Ardrossan Harbour Update Consultation Report

For and on behalf of:-
North Ayrshire Council

Document Ref. 50508
Report Issue: V2.3
July 2022
Author: JMF

Proposed Ground Floor Plan
Scale 1:200 @ A3

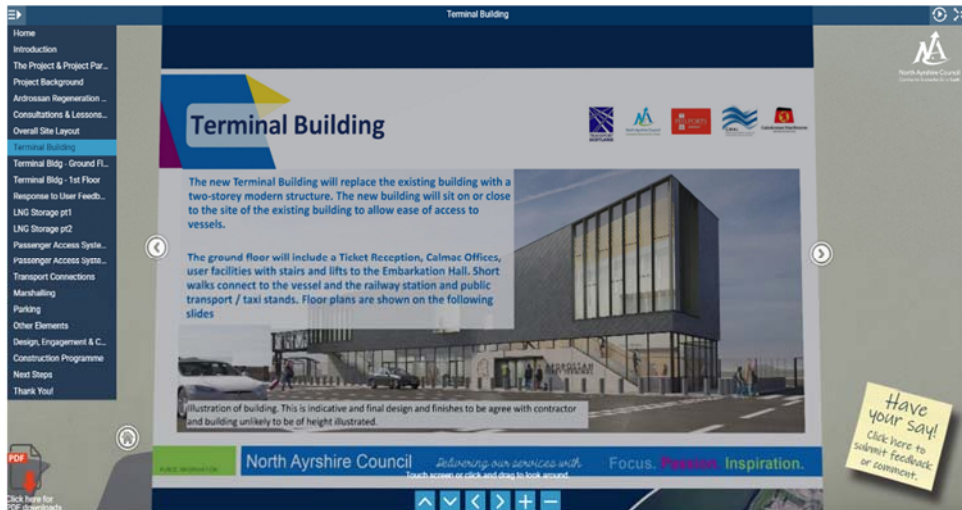
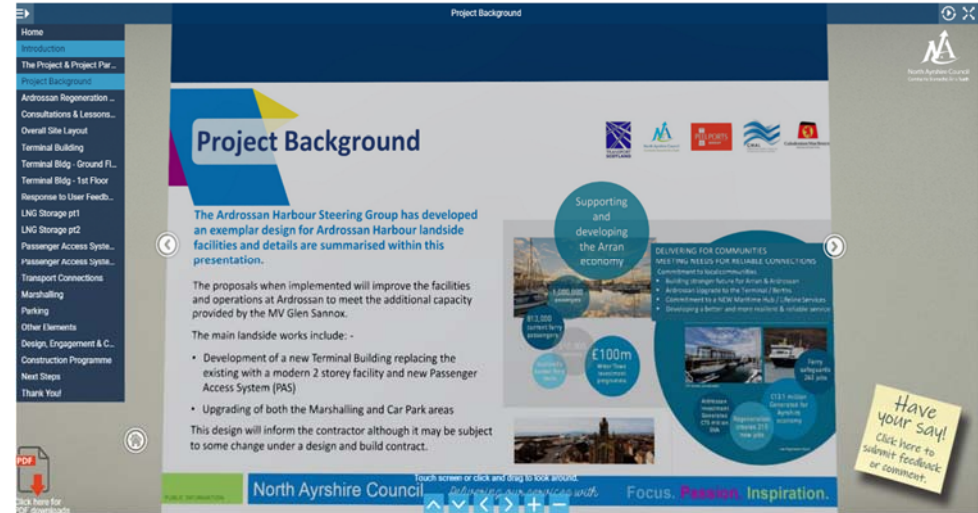
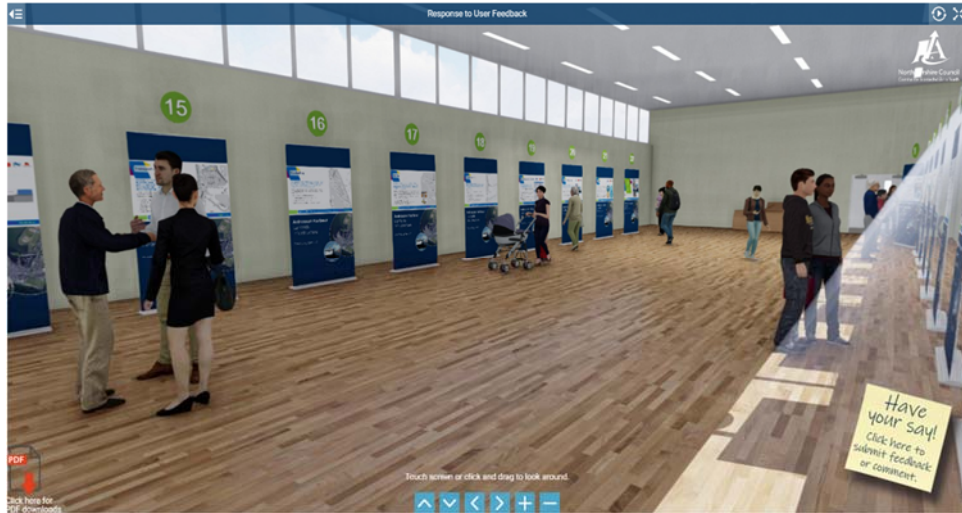
3	New stairways must have shallower gradient than Brodick and show a tangible improvement.		New stairs should demonstrate a material improvement.		Building Regulations allow a maximum stair pitch of 34 degrees. INCH have no dwg drawings of Brodick, however from pdf drawings we estimate the pitch to be between 33-34 degrees. For Ardrossan, both the Embarkation Stair and Arrival Stair have been designed to be 26.2 degrees, with the Embarkation Stair lowering to 17.4 degrees for the final flight. The escape stair has been designed to 33.3 degrees to minimise area, but this stair is not expected to be used frequently by passengers.		Brodick stairway pitch is 34 degrees whereas the pitch being applied to Ardrossan stairways is reduced to 26 degrees for both stairways with the embarkation stairway further reducing down to 17 degrees for the final flight. The emergency escape stair has been designed to 33 degrees.

5	Lift capacity must be higher than Brodick. Material improvement must be demonstrated.		We must demonstrate that we have materially improved lift capacity over Brodick and explore the options suggested.		Calmac confirmed that the lifts at Brodick have a 13 person capacity. The Ardrossan proposals are based upon a lift capacity of 17 people. Calmac were provided with the lift information, and were happy to proceed on this basis. Uplift of 30% capacity		Calmac have confirmed that the lifts at Brodick have a 13 person capacity. The Ardrossan proposals are based upon a lift capacity of 17 people resulting in a 30% uplift in capacity.
6	Four lifts instead of two to provide contingency in event of maintenance/breakdown.		Higher capital/ maintenance cost and impact on layout. Although need to have contingency for breakdown/maintenance.		See point 2 above.		No requirement for extra lifts due to significantly increased lift capacity. Furthermore, spare lifts as a contingency are not justifiable on the grounds of installation and maintenance costs.

7	Space outside lifts must be adequate to deal with congestion.		Passenger flow analysis should address this.		Lift transfer rates provided to Calmac during design process and lift arrangement agreed. No overall building flow analysis has been completed, but lift passenger flow rates were provided to Calmac, who accepted the design. The design has been agreed with Calmac, who were considering management of passenger flow, waiting spaces etc.		The current layout has been arrived at and agreed with Calmac after responding to all of Calmac comments regarding the scale of area that can be provided within the current building size. A larger building or removal of other specified spatial demands will provide greater space around the lifts.
